## Product Change Notification

**1. ECR #:** 24-12776-1  
**Notification #:** 752

**3. Series:**  
• SEAM - SEAM .050 PITCH TERMINAL ARRAY ASSEMBLY

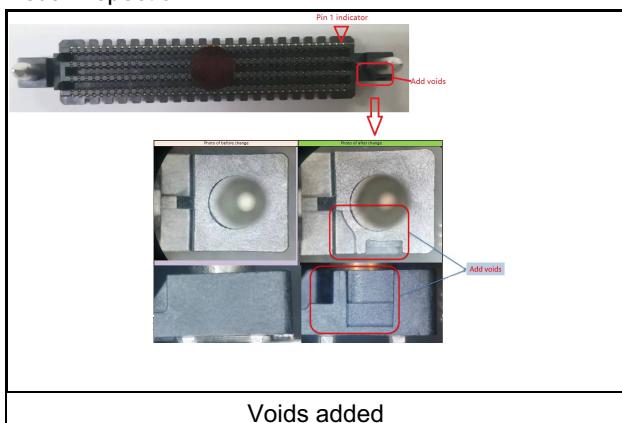
**5. Description of Change:**  
Voiding added to the insulator body near the guide post and only for the -GP style to improve robustness and manufacturability.

Voids added

Voiding added to improve robustness and manufacturability. This will be a rolling change.

- Form - This will be a form/appearance change.
